Gatwick Airport Northern Runway Project – Development Consent Order (DCO)
Written Representations for Deadline 8 , 7th August 2024

Gatwick Area Conservation Campaign (GACC)
7th August, 2024

GACC response at DCO Deadline 8 on 7th August, 2024

Figure 1. Sewage Network in the Crawley Area. Source: Thames Water

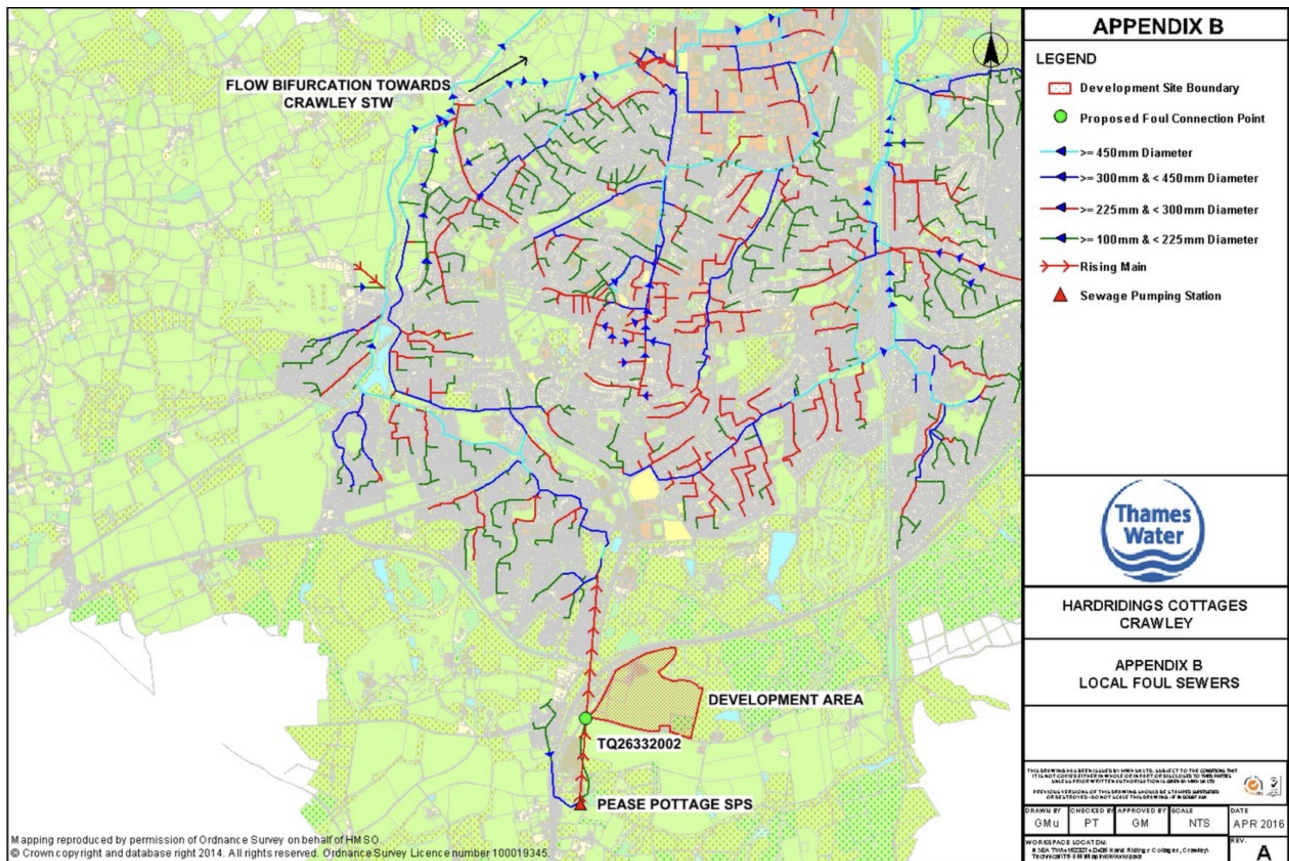
RMRW highlight increasing local evidence of increased sewage overflows following housing growth. For example, Thames Water objected to planned growth (of housing) of 600 homes at Peas Pottage. This is on the same sewer network as Gatwick (see Figure 1 below).

This highlights the importance of providing sufficient sewage pumping and treatment capacity from the airport to its two struggling sewage treatment works at Crawley and Horley, and the risk both of current operations and planned growth on storm overflows from sewage works. Horley sewage works is already failing to cope such that some of Gatwick's current wastewater flows end up, regularly, in the River Mole.

Figure 2. Event duration monitoring at Pease Pottage sewage pumping station

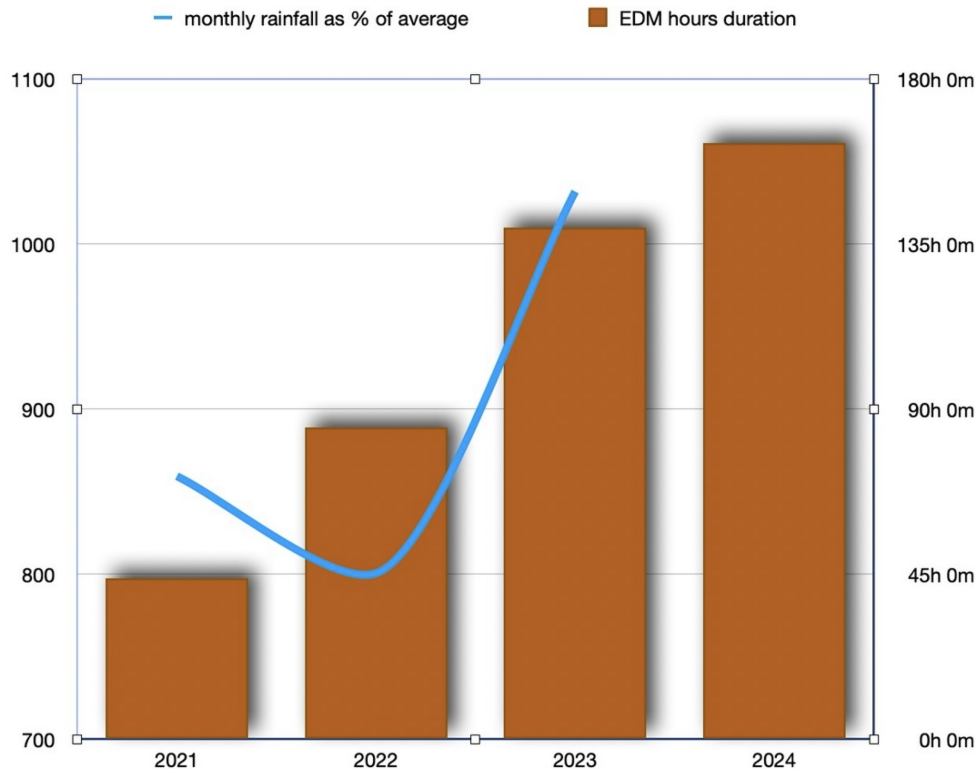
Since the development the Pease Pottage sewage pumping station has seen an increase in storm overflow activity. **Figure 2** (below) shows how storm overflow durations have shown a year-on-year increase in sewage overflow event durations in recent years into the vulnerable Stanford Brook. Whilst there is some correlation with rainfall it is insufficient to say this is the only causal factor.

Figure 3. Mole Catchment river response to modest August 1st 2024 thunderstorm and photos of similar event in 2022.

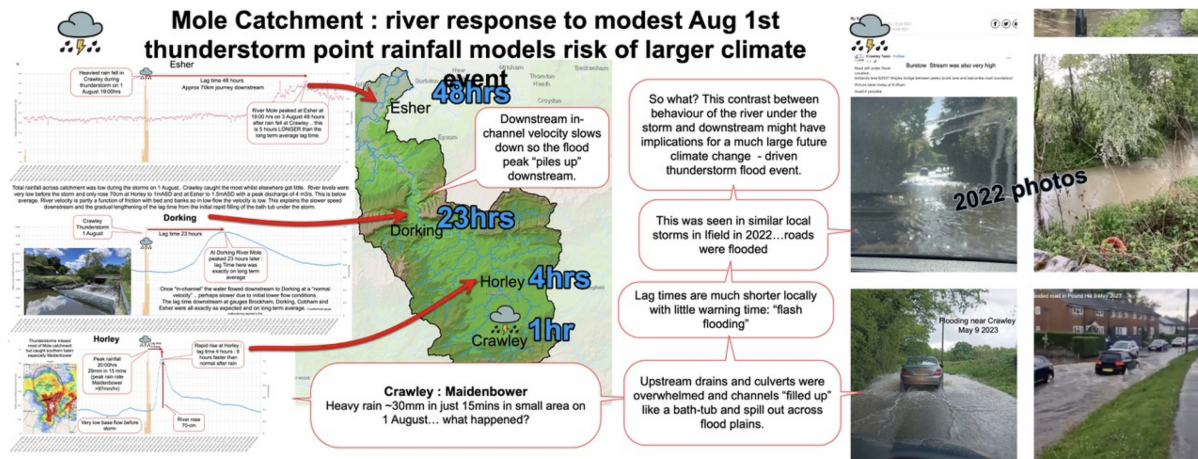
Figure 3 (appended in landscape format for clarity) highlights a recent example of where **the flood risk model does not reflect the local flash flood risk**. This figure presents data from a modest thunderstorm in August 2024 that dropped 30mm over Maidenbower and photos related to a similar summer thunderstorm over Ifield in 2022. Both were quite tight rainfall events that resulted in localized flash flooding.

This is typical of local heavy rainfall events where rain from impermeable surfaces reaches the river in minutes, resulting in flash flooding. This tends to overtop and flood locally very quickly before then proceeding further downstream at a more average speed will be exacerbated by climate change. As a result this thunderstorm in Maidenbower reached Horley in 4 hours, 6 hours quicker than normal. This modelling highlights that such storm events fill up local water courses like "bath tubs" within minutes and hours of deluge point rainfall giving effectively no warning. This contrasts the 24-hours for floodwater to travel from this area to reach the River Thames at Esher or Molesey.

As climate change is increasing the likelihood of more severe flood events, and more intense rainfall events it would appear that even with a 1:100 year event the flood, risk, specifically flash flood risk from a local rainfall event, would appear to be underexplored and understated.

GAL should undertake further flood risk assessment investigating the risk and mitigation of such local flash flooding and the local Flood Risk Authorities should also consider whether the introduction of the FCAs on the River Mole would result in any impact on flood peaks travelling further down the River Mole.
